# FE-244

## DESCRIPTIVE REPORT

Type of Survey ... Hydrographic Field Examination  
Field No. .... R/H-20-3-83  
Office No. .... FE-244

ATLANTIC MARINE CENTER  
EVALUATION REPORT

FE - 244

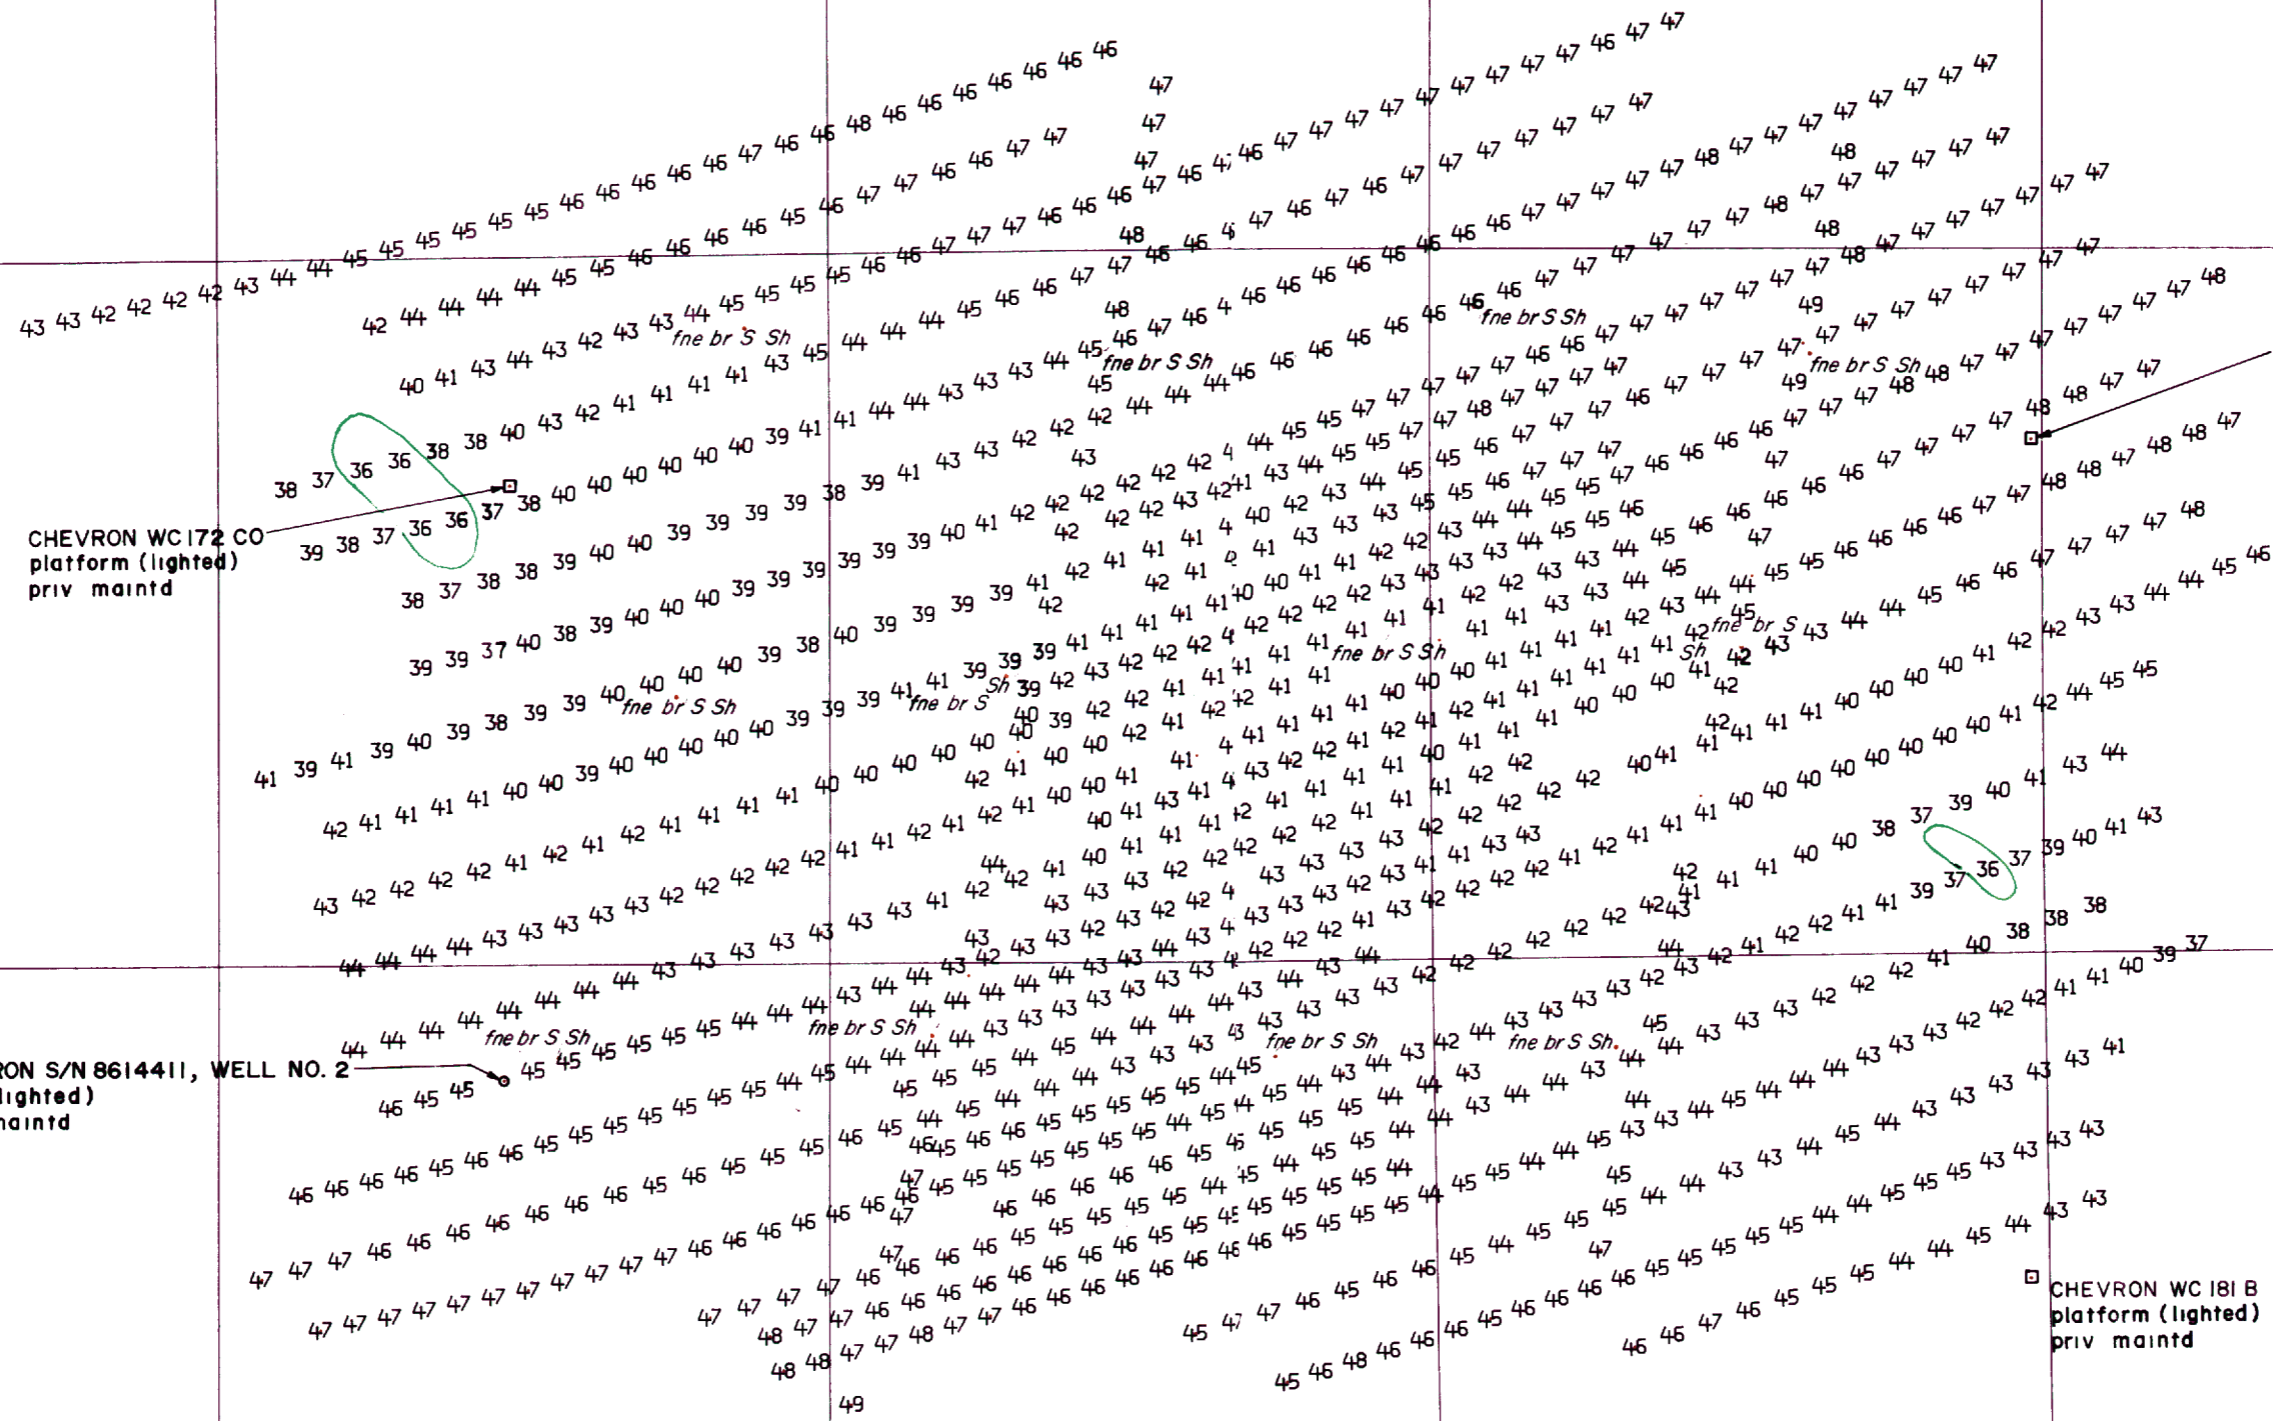
b. No standard depth curves were drawn on the smooth sheet. Depths range from 36 to 49 feet. The supplemental 36-foot curve is shown to define the shoal characteristics within the area. The 36-foot curve on the shoal in approximately Latitude 29°22'40", Longitude 93°14'40" was closed based on prior survey H-8738 (1962-63) hydrography.

(1) The isolated 36-foot shoal in approximately Latitude 29°22'10", Longitude 93°12'10" was not adequately defined. The area should have been

developed to define the extent and least depth of the feature. This isolated shoal is charted.

(2) The isolated 36-foot shoal in approximately Latitude 29°22'40", Longitude 93°14'40" was not adequately defined. The area should have been developed to define the extent and least depth of the feature. This isolated shoal is charted.

The charted hydrography originates with the previously discussed prior survey of H-8738 (1962-63). The disposition of charted soundings common to this field examination is adequately discussed in section 6. of this report. The charted "(38ft. rep 1976)" in approximately Latitude 29°22'30", Longitude 93°13'00" should be deleted from the chart.
